SERVICE INFORMATION LETTER

SERVICE INFORMATION LETTER INDEX

SUBSIDIARY OF ISRAEL AIRCRAFT INDUSTRIES. LTD.
BEN GURION AIRPORT, ISRAEL

Figure 2

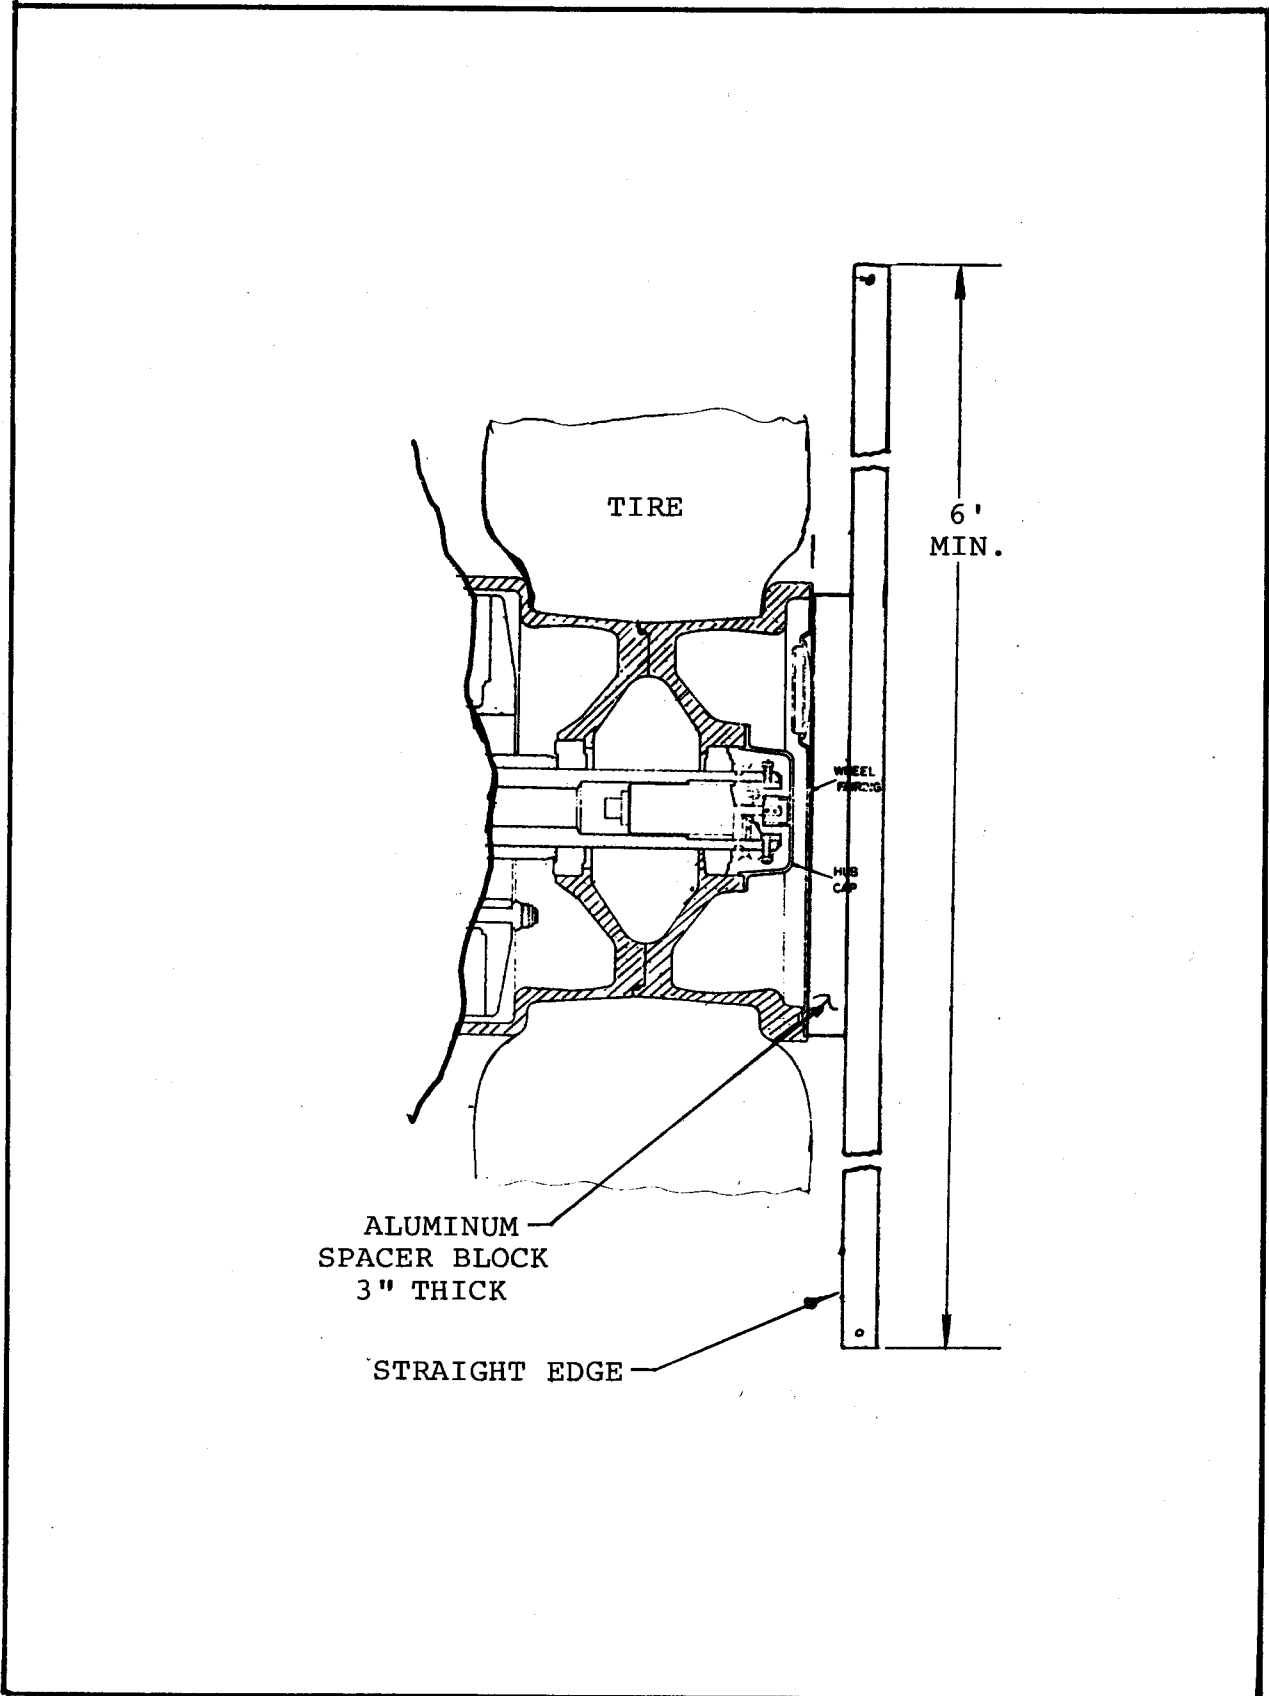
1. Prior to jacking aircraft remove fuses from jet pack emergency battery. Jack the aircraft with wing jacks and tail stand, and level it laterally. M/M-8-00-01.
2. Project the aircraft centerline on the ground as follows:
 - a. Using a plumb line, mark the centers of the nose landing gear drag brace and of the tail skid on the ground.
 - b. Stretch and mark a line between the two points marked in Step (a). SEE FIGURE 1.
3. Parallel to center line measure three and one half feet fore and aft of the center of each main landing gear on both sides and mark the lines on the floor.
4. Attach a straight edge and spacer to inboard side of wheel. The straight edge should extend a minimum of three feet fore and aft of wheel center. SEE FIGURE 2.

FIGURE 2

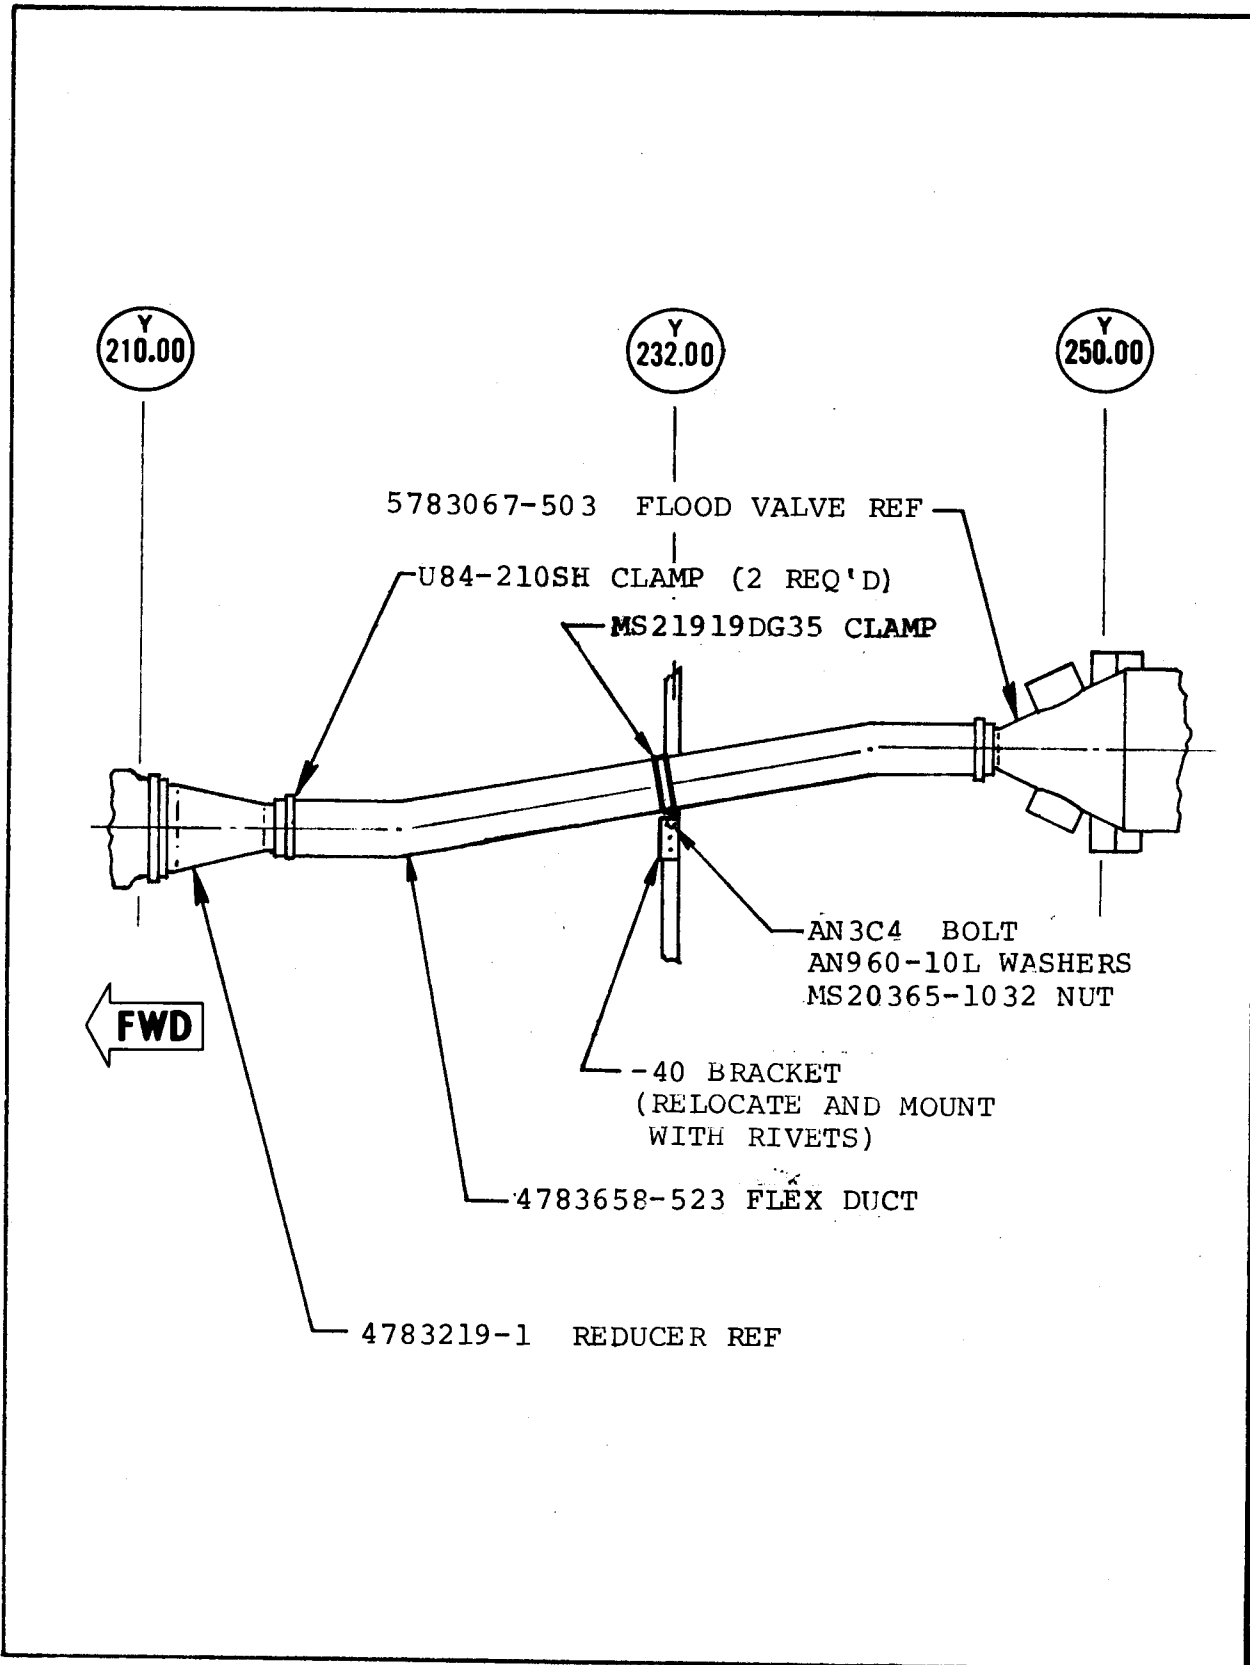
1. Gain access to air-condition muffler under the floor in rear cabin area.
2. Remove floor as required to enable work.
3. Disconnect and remove Muffler P/N 5783255-1, Flex Duct P/N 4783658-511, coupling duct, and Clamps P/N U84-210SH. Drill out rivets of -39 and -40 muffler mounting brackets; remove brackets. (SEE FIGURE 1)
4. Install Flex Duct P/N 4783658-523 between Reducer P/N 4783219-1 and Flood Valve P/N 5783067-503, using 2 each Clamps P/N U84-210SH originally removed (SEE FIGURE 2).
5. Relocate one -40 bracket to provide support for Flex Duct P/N 4783658-523, and secure with NAS1398D4-2 rivets. Install Clamp P/N MS21919DG35; locate and drill .190 dia. hole in -40 bracket for proper alignment of Flex Duct. Secure Clamp to bracket with AN3C4 Bolt, AN960-10L Washers (2 required), and MS20365-1032 Nut. (SEE FIGURE 2)
6. Close up floor and reinstall interior.

FIGURE 2

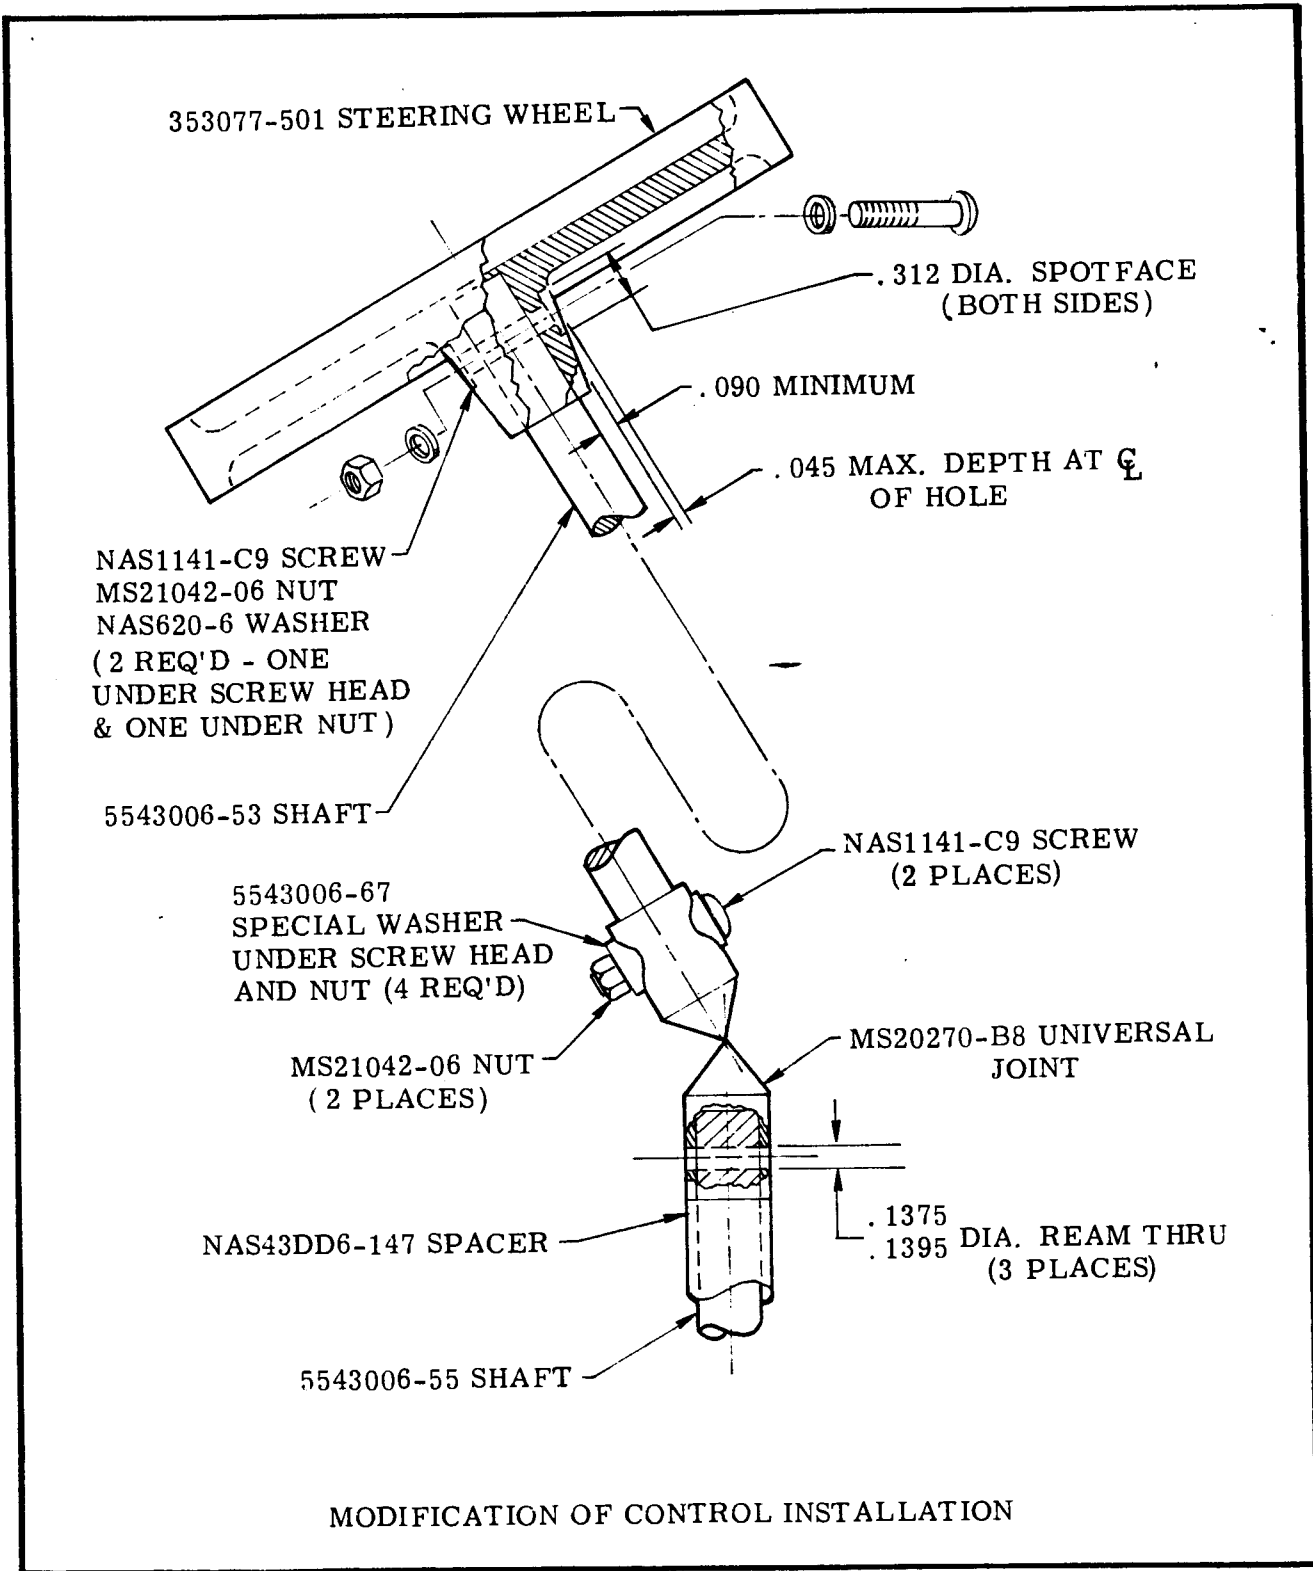
4. Install NAS 1141-C9 screw, two 5543006-67 special washers, and MS21042-06 nut, NAS 620-6 washers at both locations on universal joint. (SEE FIGURE 2)

5. Enlarge existing fastener holes in 3530077-501 steering wheel with .1375 dia. reamer. Spot face hub as shown (maintain .090 minimum thickness). (SEE FIGURE 2)

FIGURE 2

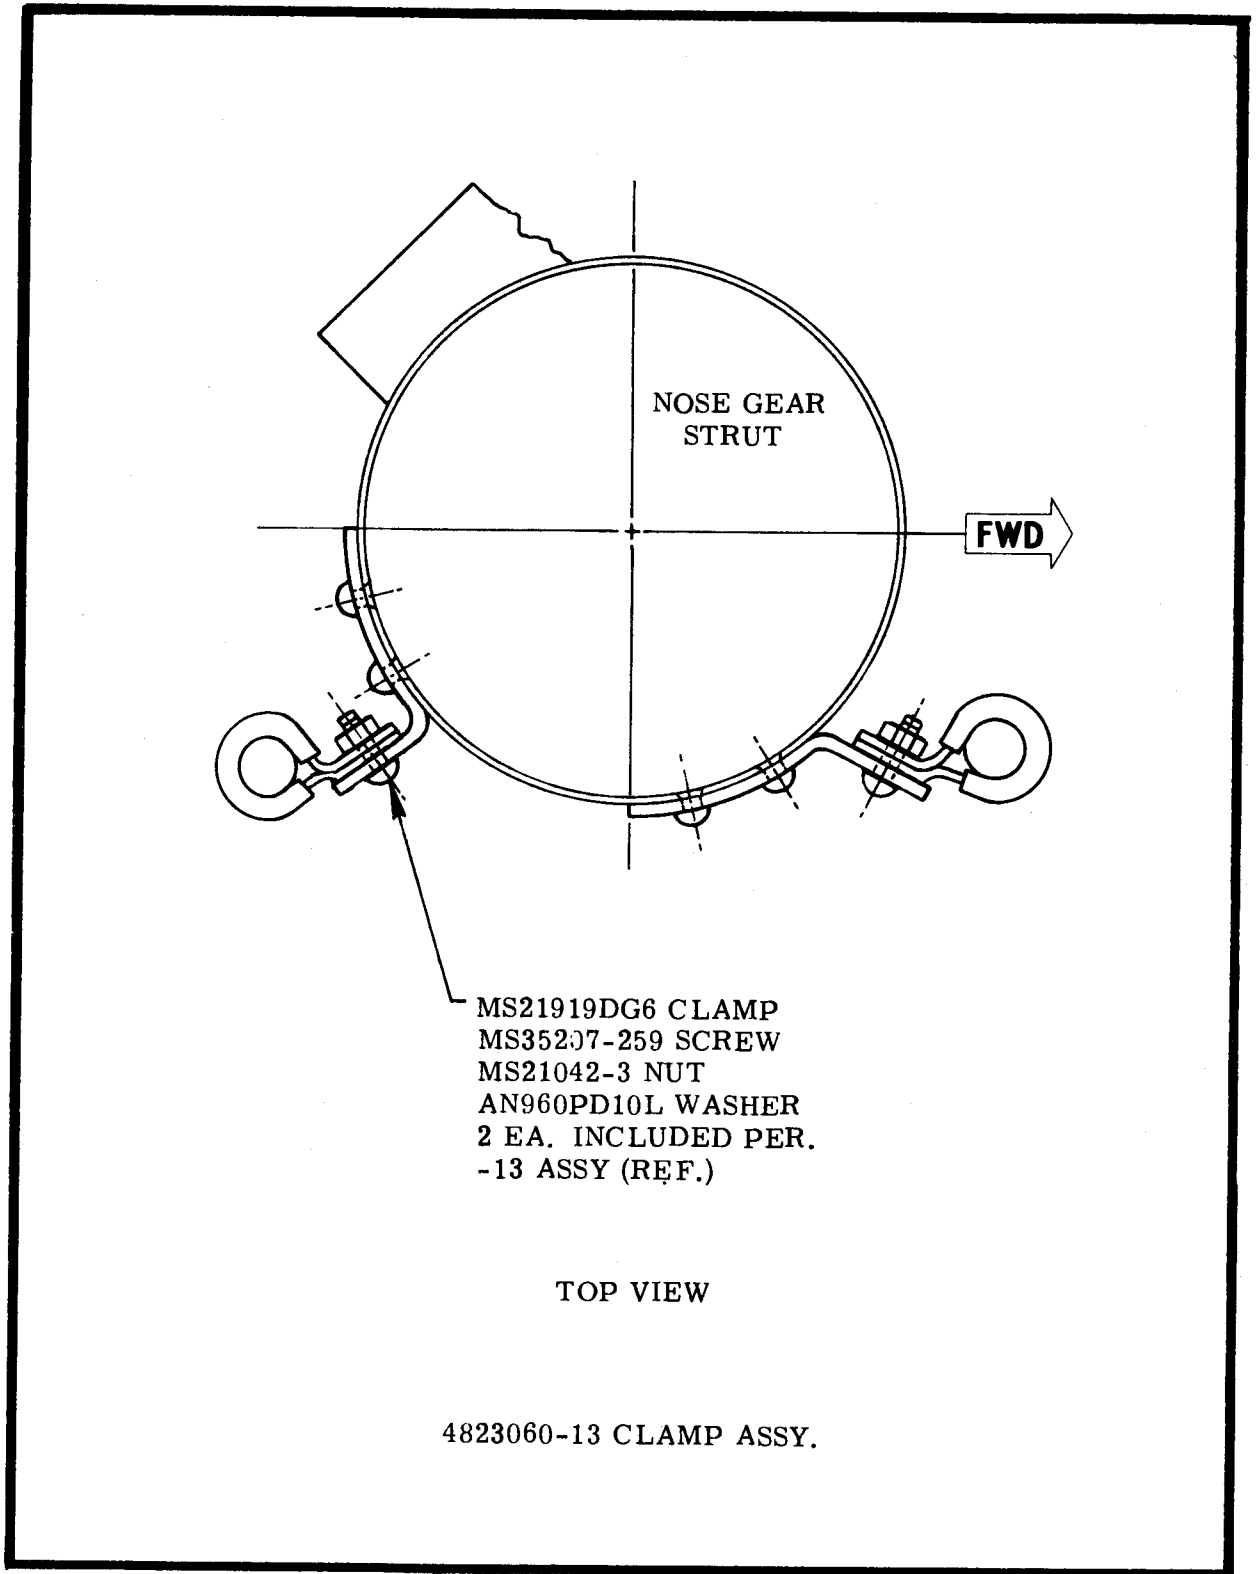
3. Install new MS25281-R8 wire bundle support clamp to 4823060-3 plate, using hardware provided, per Figure 1. Install new P/N 4823060-13 clamp assembly on nose gear strut body as per Figure 2. Check wire bundle for proper routing and freedom from stress between support clamps when nose gear is rotated to full deflection in left and right turns.

FIGURE 1

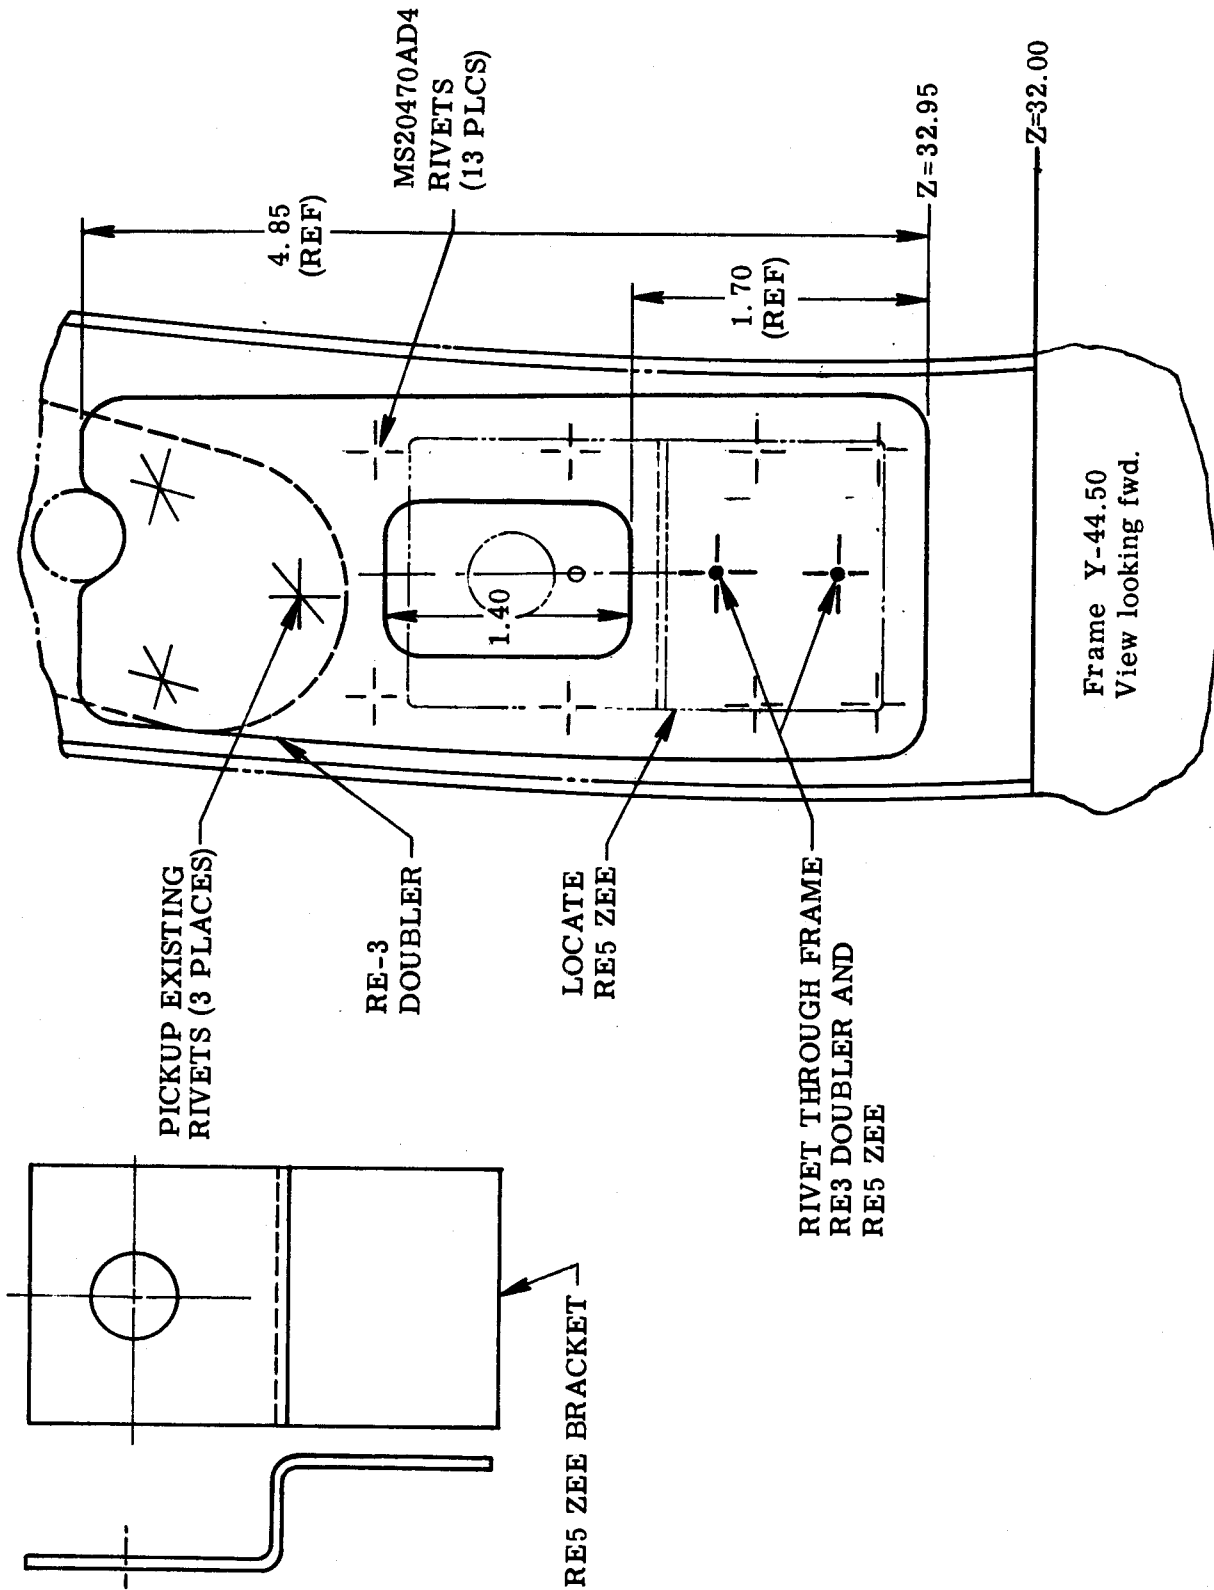
6. Install RE3 doubler and RE5 zee bracket on Fus. Sta. 44.50 frame in accordance with Figure 1.
7. Temporarily replace pilots side panel to permit locating and marking position for RE7 placard installation. Mark center of hole to be drilled to accommodate nose steering sensitivity switch installation.

9. Install the 1TL1-2 switch in the RE5 zee bracket that was previously installed (See Figure 1).
10. Drop overhead circuit breaker panel and remove and discard existing 3 amp. nose steering circuit breaker. Install new 5 amp. nose steering circuit breaker and secure circuit breaker panel.
